**GLENORCHY PLANNING AUTHORITY  
ATTACHMENTS  
MONDAY, 13 MAY 2019**

- 5. PROPOSED USE AND DEVELOPMENT ADDITIONS AND ALTERATIONS TO MULTIPLE DWELLINGS (RESIDENTIAL) - 3 WILLOW WALK AUSTINS FERRY**
  - 1: Attachment - 3 Willow Walk Austins Ferry ..... 3

**8. PROPOSED S.43A COMBINED AMENDMENT REQUEST & PLANNING PERMIT APPLICATION - TO APPLY A SITE-SPECIFIC QUALIFICATION FOR 'STORAGE' AND ALLOW FOR A HIGHER BUILDING AND PLANNING PERMIT APPLICATION FOR SELF-STORAGE FACILITY (STORAGE) AT 483-485 MAIN ROAD MONTROSE (PLS43A-18/02)**

Figure 1: Inundation modelling completed as part of the Glenorchy CBD Stormwater System Management Plan (2018).

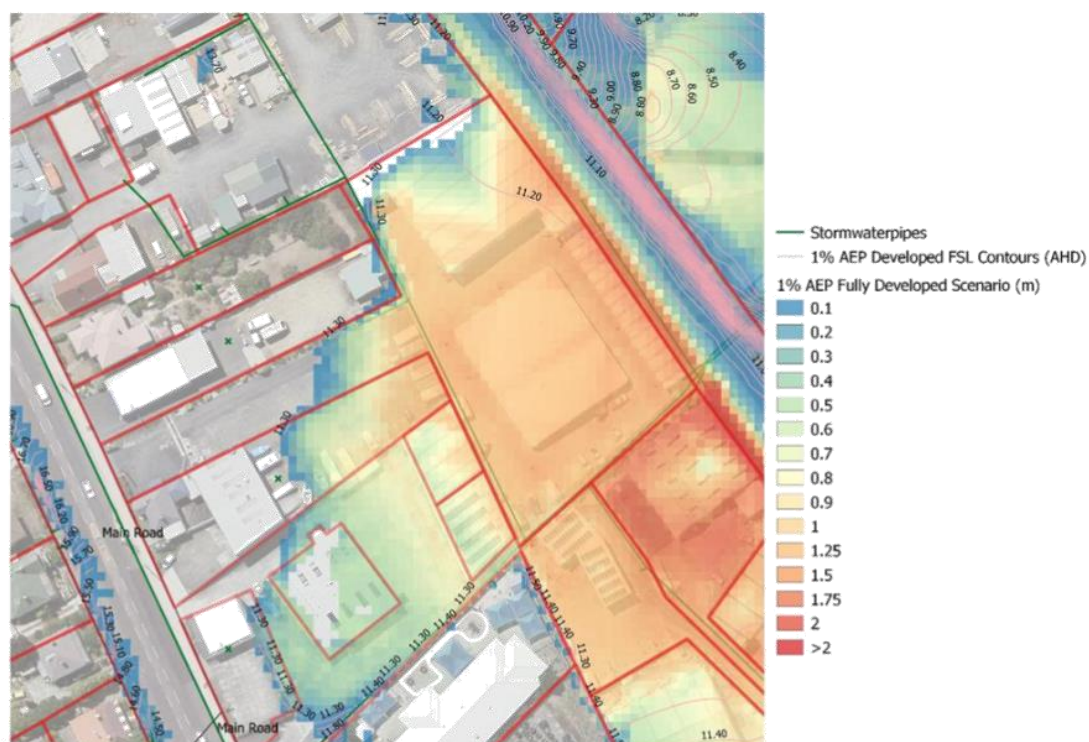
Several flood studies conducted by the council have identified that the area is prone to flooding during heavy rainfall events. In the Glenorchy CBD Stormwater System Management Plan (2018) it is estimated that the inundation depth at the location could be from 0.1m to 1.3m above the natural surface level in a 1% AEP storm event. This is shown in Figure 1. Furthermore, the same study has identified the site as being in a flood hazard area, shown in Figure 2. The same conclusion was made in the Flood Evacuation Management Plan and Early Warning System for CBD and Surround in 2013.

Figure 2: Flood hazard modelling completed as part of the Glenorchy CBD Stormwater System Management Plan (2018).

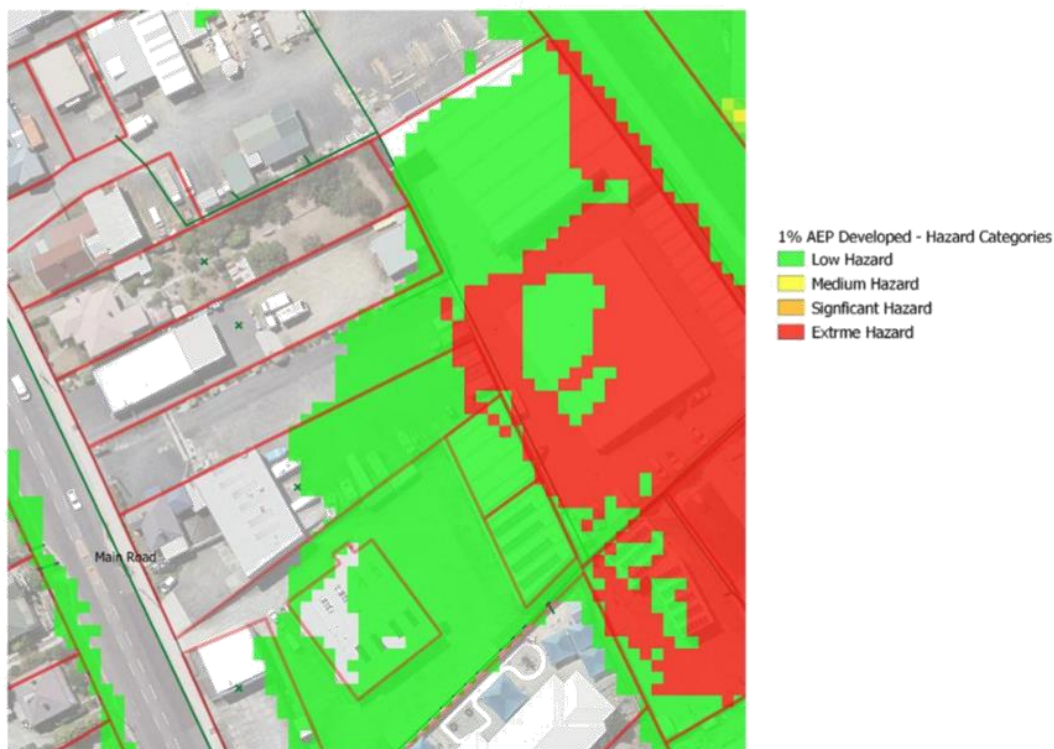
To ensure that risk from riverine, watercourse or inland flooding is appropriately managed the GIPS requires Acceptable Solution A3 to be met, or otherwise Performance Criteria P3 to be addressed. P3 applies as the building area is greater than 60 square metres.

SMEC has determined that the risk to users on the site, adjoining or nearby land can be deemed acceptable if its recommendations are adhered to. The recommendations detail design features to implement and procedures to follow. It is my view that each recommendation should be strictly followed to satisfy Performance Criteria P3.
